PALO VERDE COMMUNITY COLLEGE NEEDLES CENTER INTERIM STUDENT HOUSING (Site Preparation and Utility Connection for New Portables) INFORMAL BID NO. 2019-01

ADDENDUM NO. 1

July 18, 2019

SHEET 3

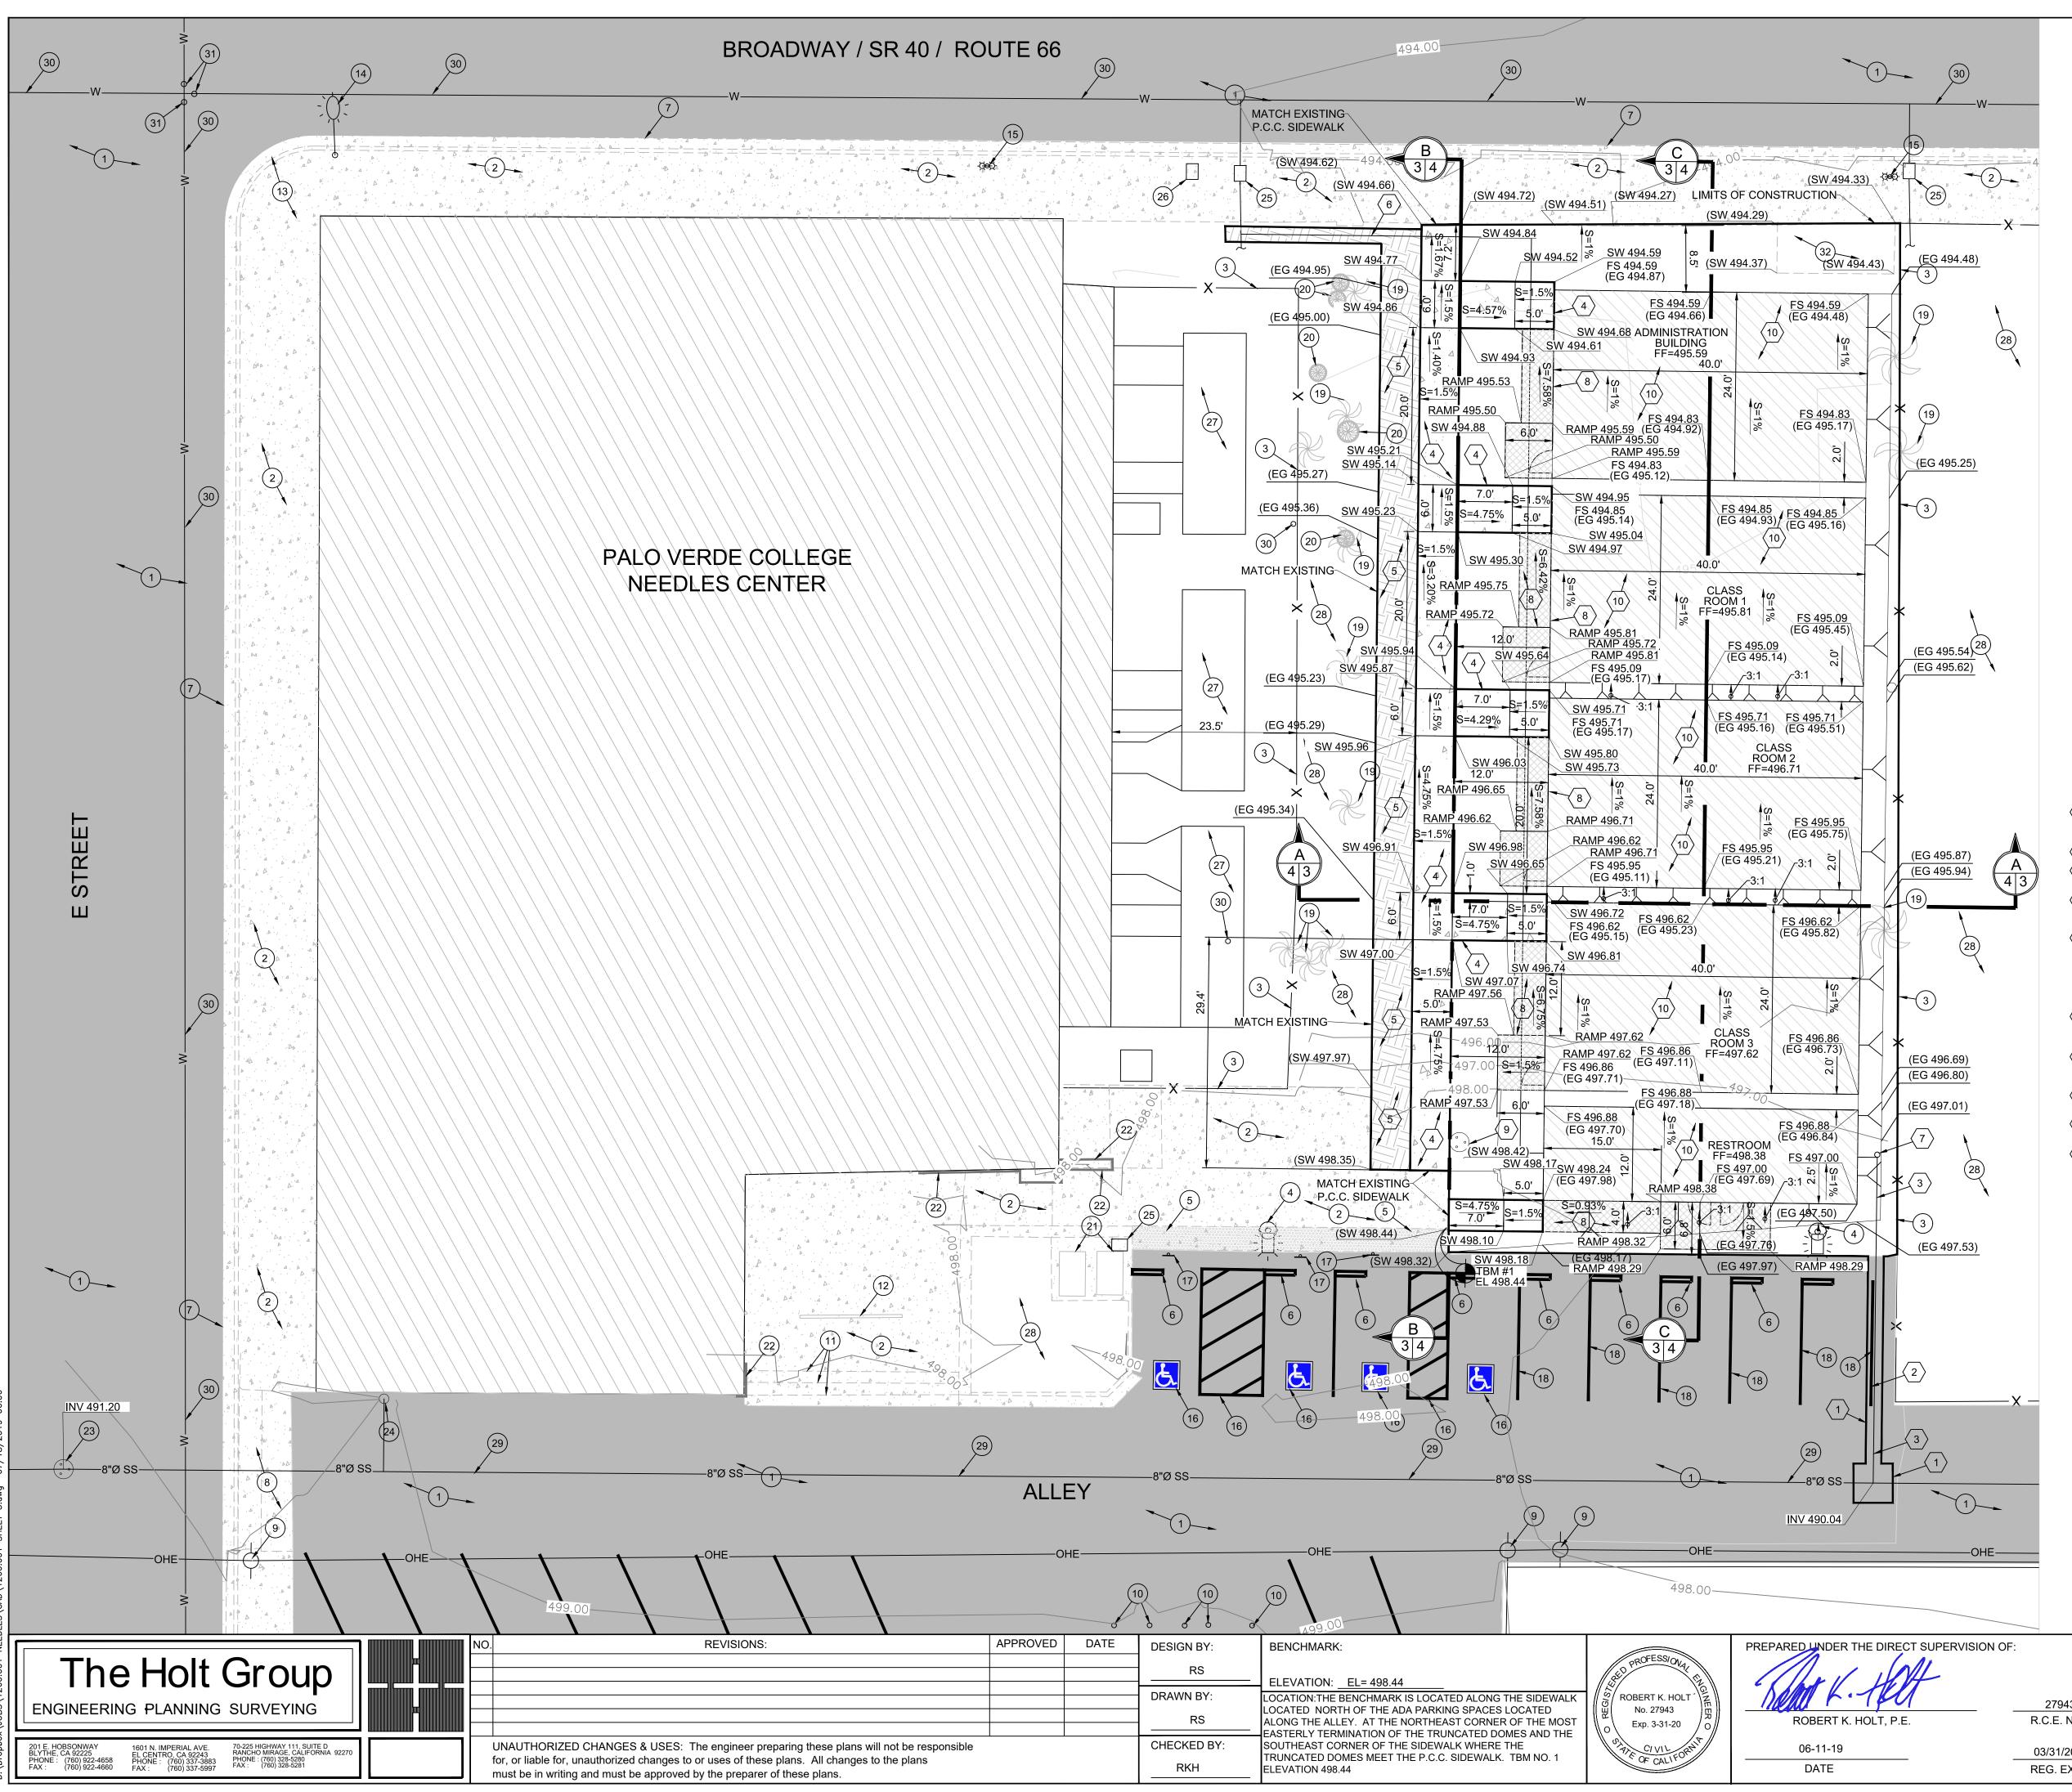
RFI 1 Question: Can we tie into the existing 1" water main underground that feeds the two existing hoe bibs that are on the east side of the air handlers? ILO running a new line from the meter. I believe this hose bib line runs to the meters anyway.

Plan Clarification:

- 1. Existing Keynote 23 on Sheet 2 is an existing manhole that is approximate 6 ft. deep and appears to be abandoned. The Contractor shall adjust the manhole frame and cover to finish grade. No other work associated with this manhole is anticipated.
- 2. An examination of the adjacent upstream and downstream manholes located 230 ft. westerly and 140 ft. easterly, respectfully, of the proposed tie point for the sewer lateral called for by construction Keynote 3 on Sheet 3 revealed that the existing sewer main is 8 inches in diameter flowing west to east. The invert elevation at the tie in point is approximately 490.04.

RFI 1 Response: Yes, it is okay to connect to the 1" water main that feeds the two (2) existing hose bibs in lieu of running a new line from the meter.
